REMARKS**OBJECTION TO THE TITLE**

OBJECTIONS TO THE DRAWINGS AND SPECIFICATION

REJECTION UNDER 35 U.S.C. §102

Fig.1

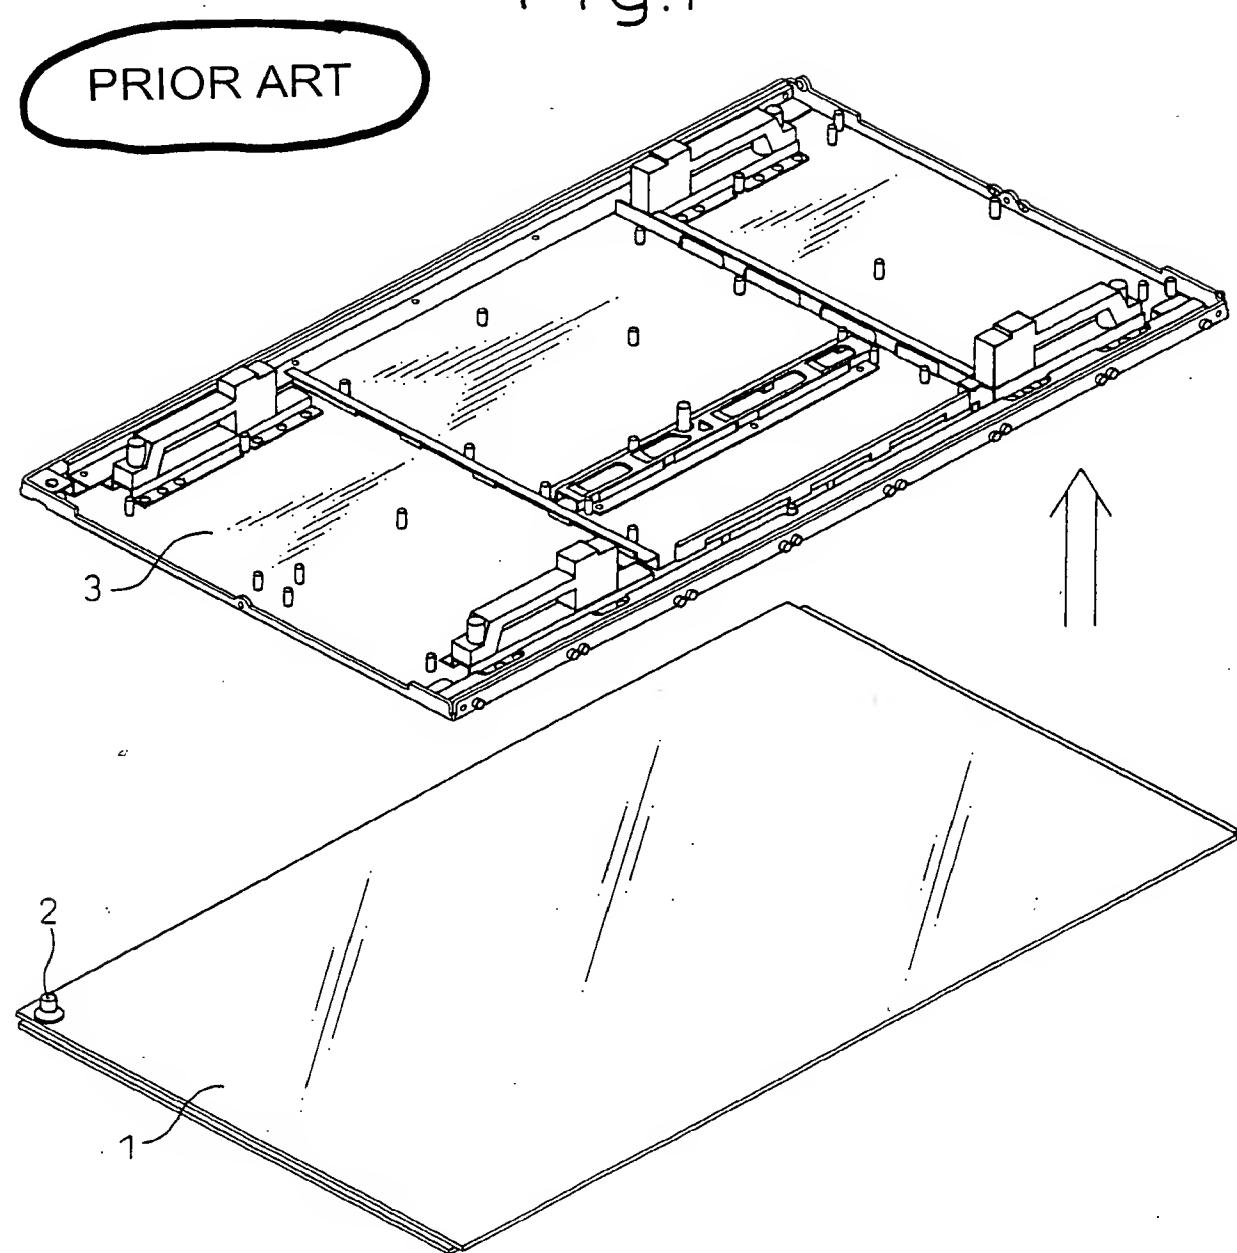
In the Office Action, at page 2, numbered paragraphs 3-4, the drawings were objected to.

Corrections to FIGs. 1-3 by addition of the terminology "PRIOR ART" have been requested and replacement figures have been submitted herewith. Therefore, the outstanding drawing objections should be resolved.
